## Addendum #2

Issued April 14, 2025

**WESTDALE SECONDARY SCHOOL**  
HAMILTON - WENTWORTH DISTRICT SCHOOL BOARD  
700 MAIN STREET WEST  
HAMILTON, ONTARIO

1 PARTIAL BASEMENT FLOOR PLAN - PROPOSED  
A2.01 1/4"=1'-0"

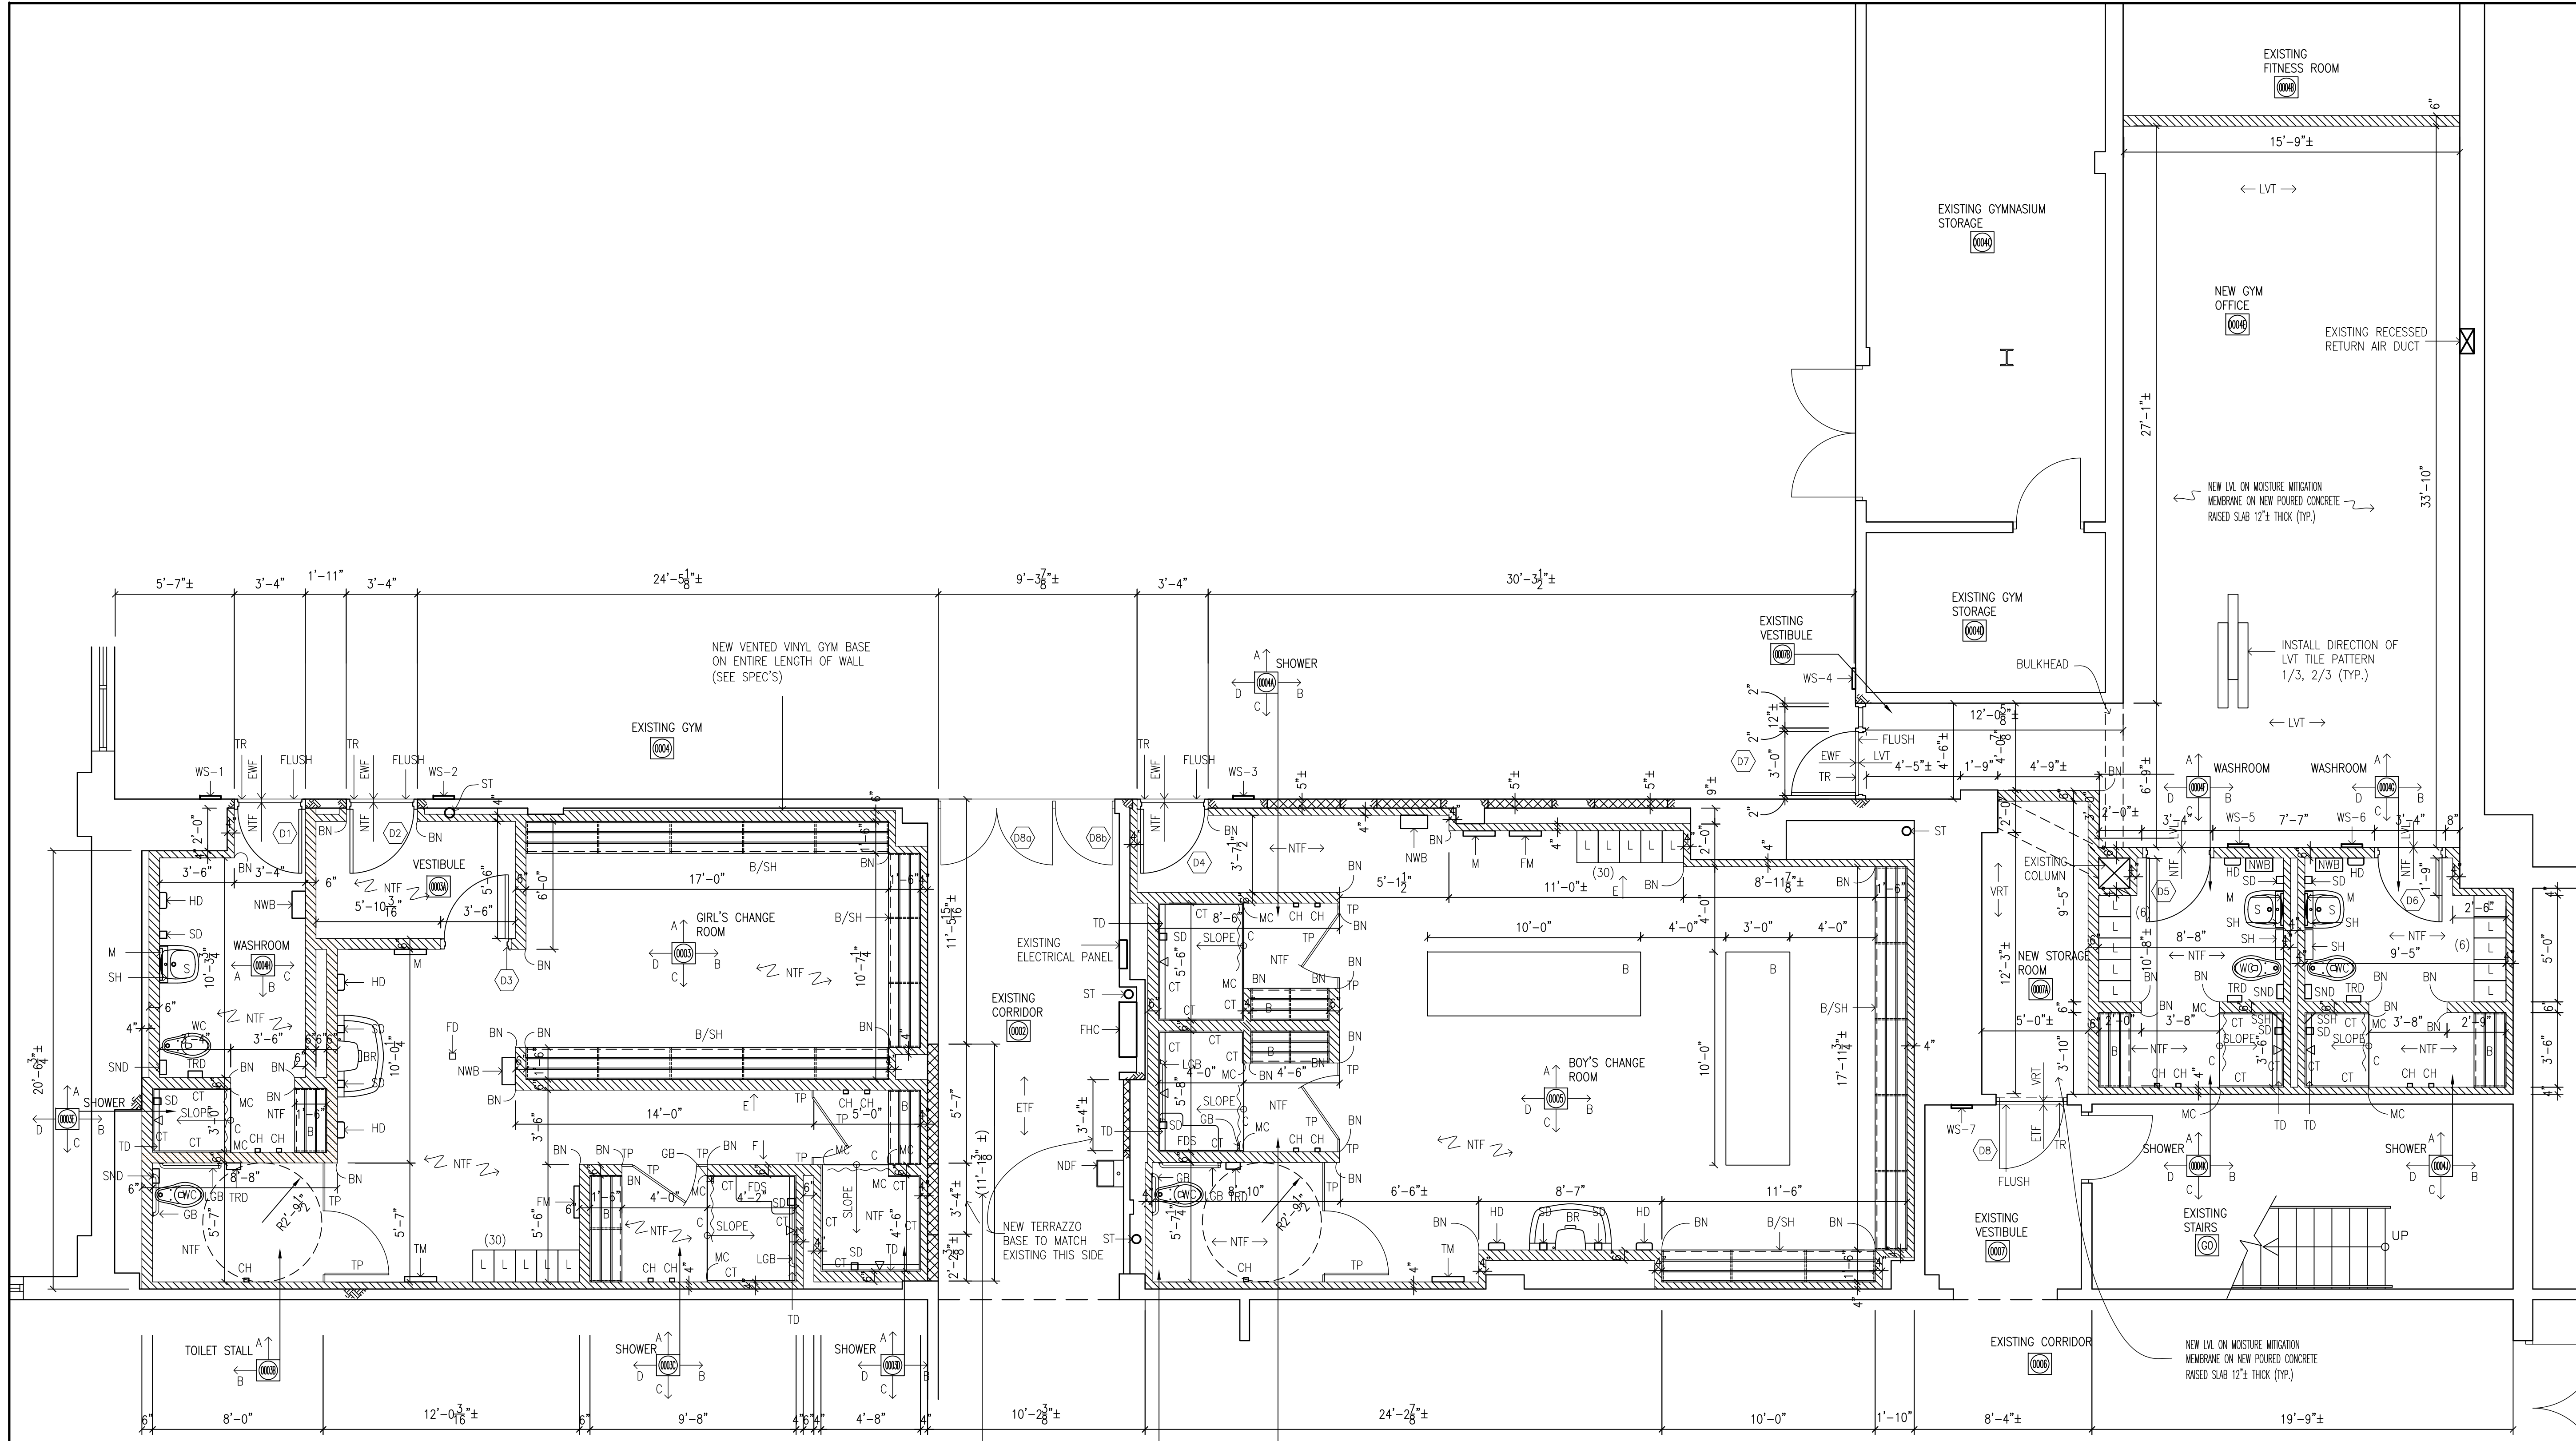
- Q15 Could you clarify the exact floor finishes required for the showers? I noticed NTF is specified on drawings A2.01 and A2.02, while LVL is listed on the Room Finish Schedule.
- R15 Please see attached revised drawing A4.02

NEW LVT ON MOISTURE MITIGATION MEMBRANE ON NEW POURED CONCRETE RAISED SLAB 12"± THICK (TYP.)

NEW 3/4" MIN. THIN-SET CEMENT SEAMLESS TERRAZZO ON DRY PACKED CEMENT BASE C/W 6" PERIMETER PRECAST COVE SEAMLESS TERRAZZO BASE. IN SHOWERS BASE WILL BE CERAMIC TILE (SEE SPEC'S)

**1** ROOM FINISH SCHEDULE  
A4.02 N.T.S.

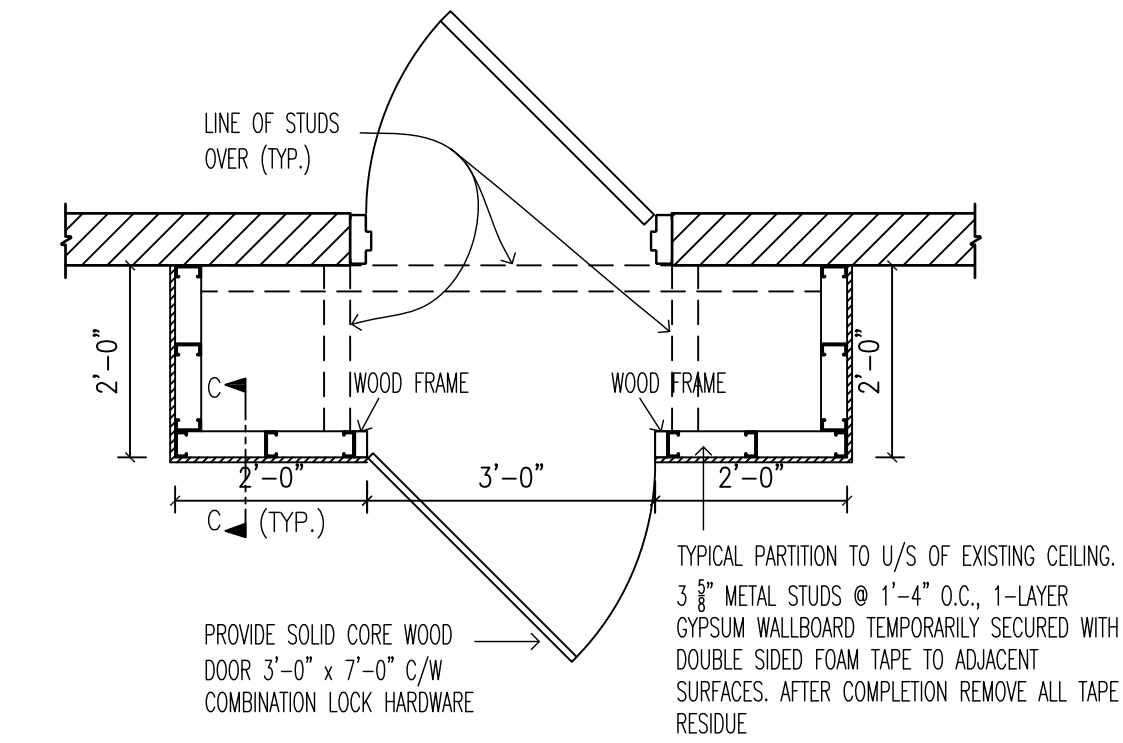
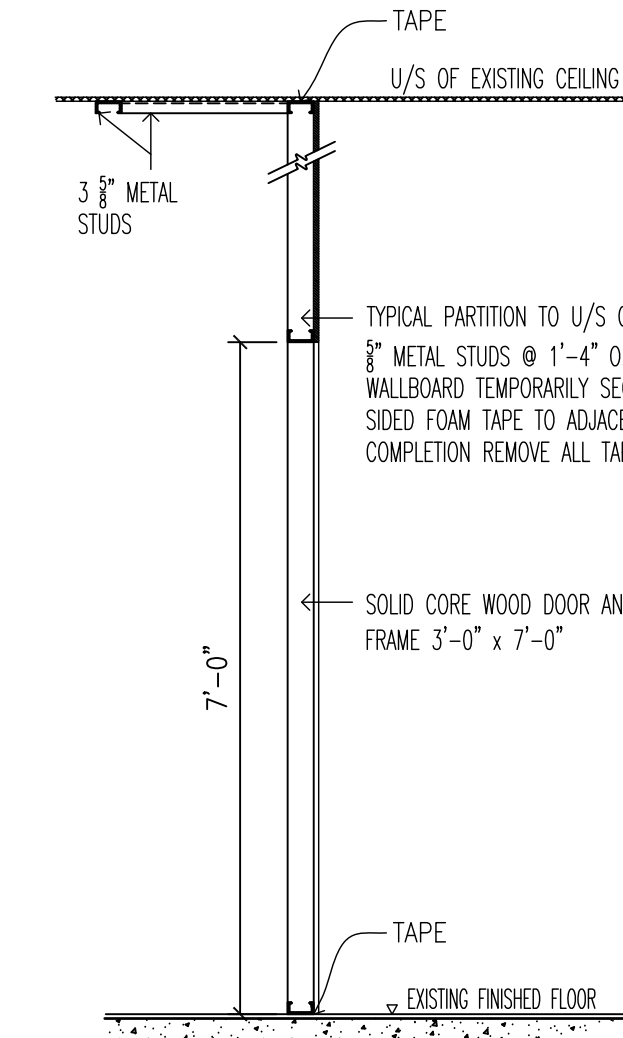
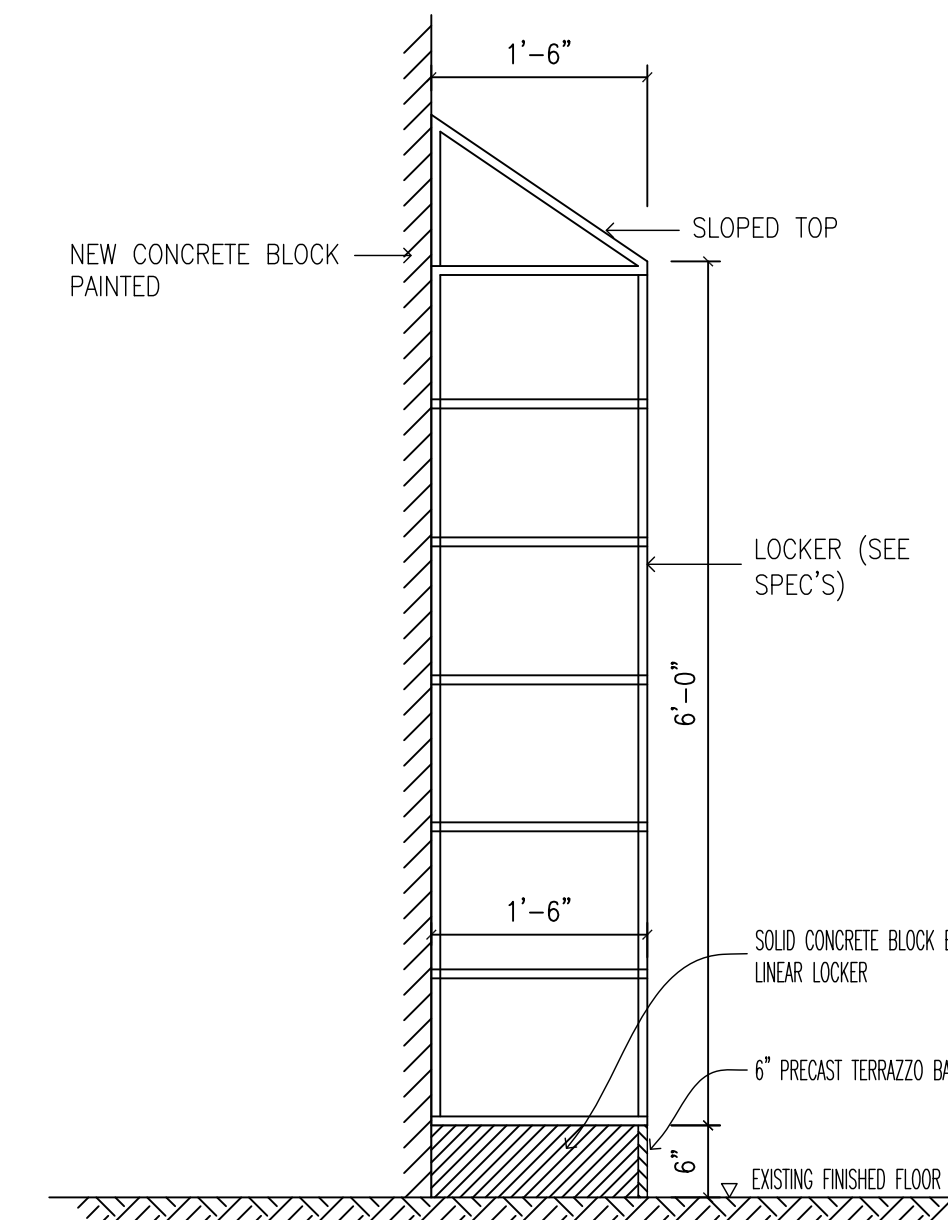
- Q7 Can the terrazzo that's being replaced be cementitious and not resinous.
- R7 The terrazzo shall be as per Specifications 09623.**
- Q8 Please can you reconfirm the room finish schedule. the schedule says not to paint the washroom ceiling but the Room Finish Schedule does not says it needs paint

- R8 Please see attached revised Drawing A4.02**
- Q9 Please confirm if corridor needs to be painted?
- R9 Painting is required at new door infills as well as around new door openings only.**
